CITY OF ROCKWALL HISTORIC PRESERVATION ADVISORY BOARD (HPAB) MEMO

AGENDA ITEM: H2018-020/SP2018-035; COA for Office Building

RE: HISTORIC (H2018-020), Foote Office

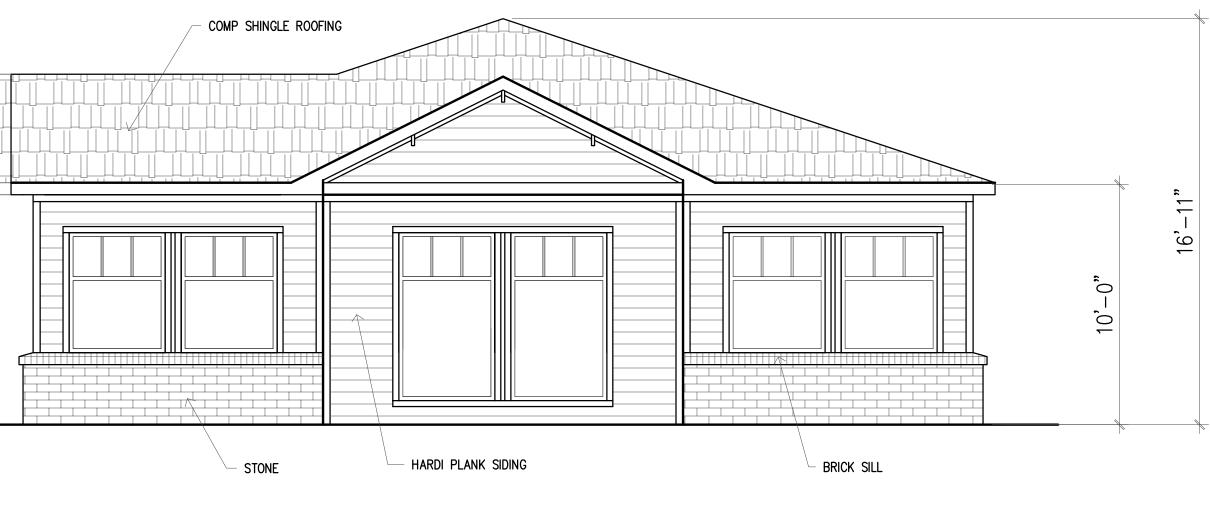
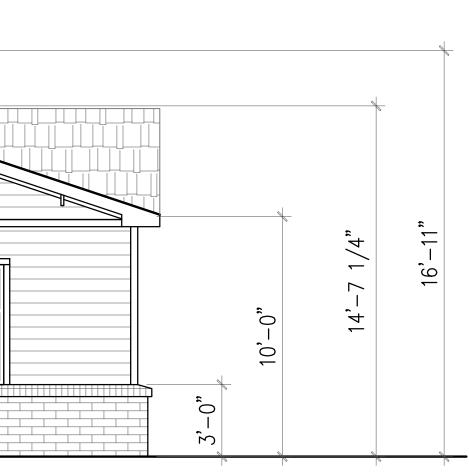
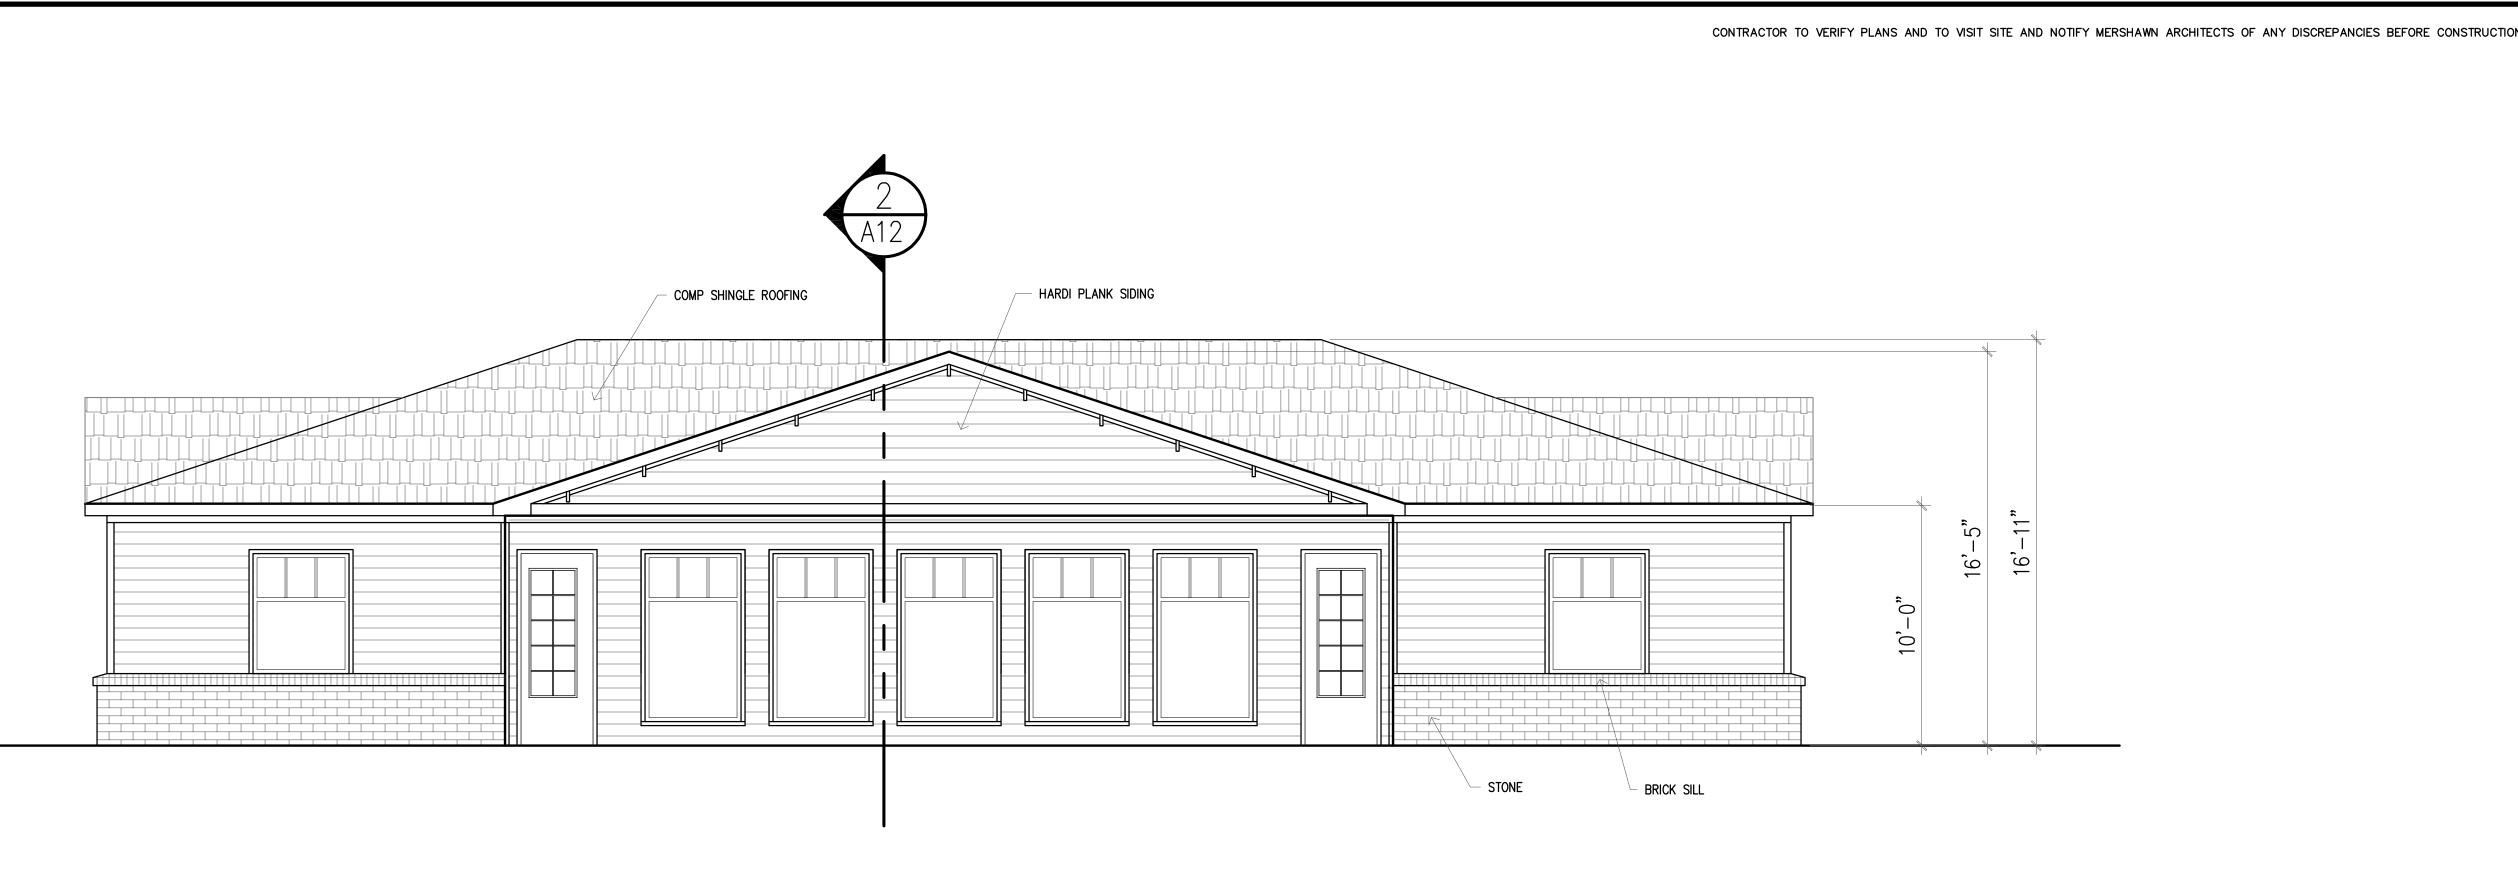
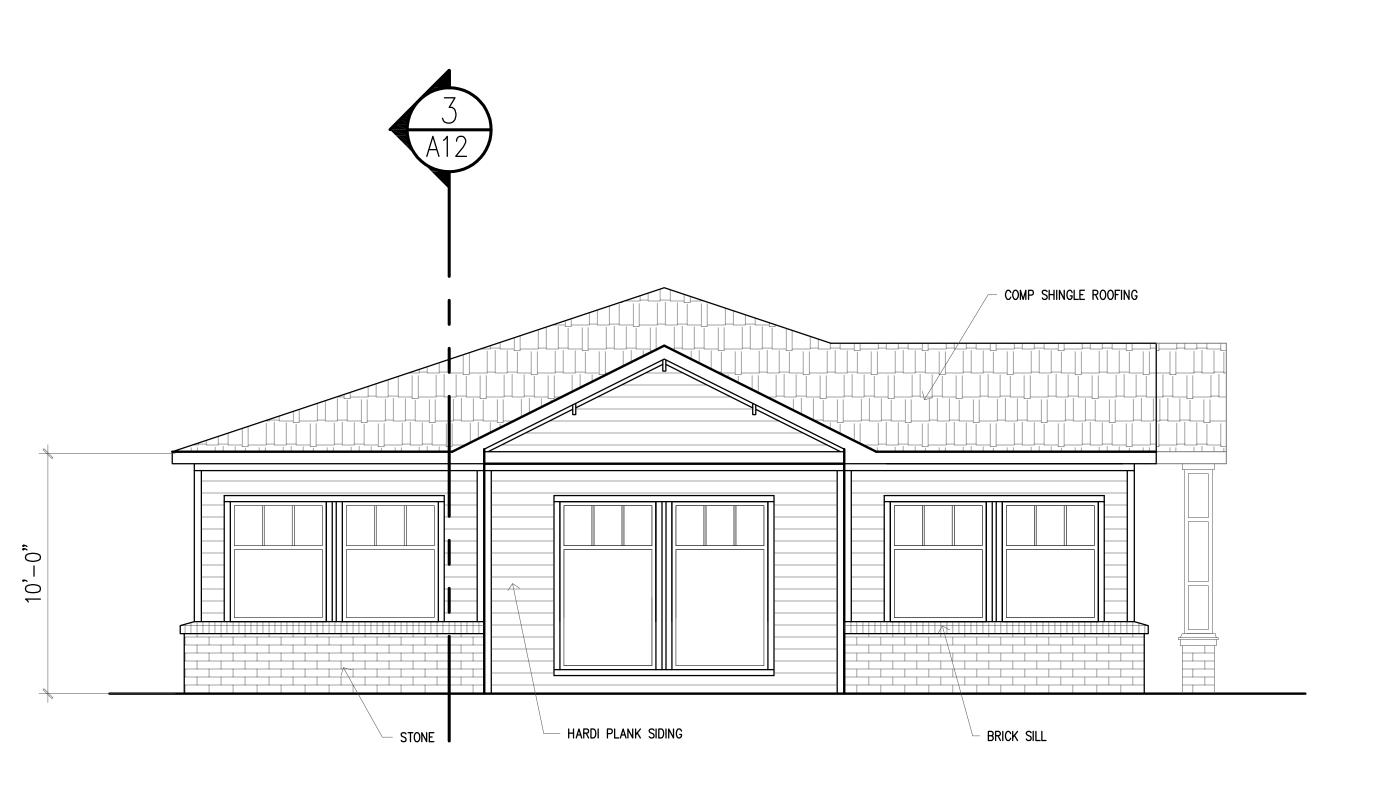
When analyzing the applicant's request (*i.e. approval of a Certificate of Appropriateness [COA] to construct an office building*), the proposed elevations seem to conform to all of the above design guidelines stipulated in the North Goliad Corridor Overlay (NGC OV) District development standards. Approval of this request does not appear to negatively impact the historical integrity of the neighboring properties; however, this is a discretionary decision for the Historic Preservation Advisory Board (HPAB).

On November 15, 2018, the Historic Preservation Advisory Board's Motion to recommend approval of the site plan for an office building with the condition that more Craftsman-style elements be incorporated into the architecture passed by a vote of 5-0 with Board Members Odom and Mishler absent.
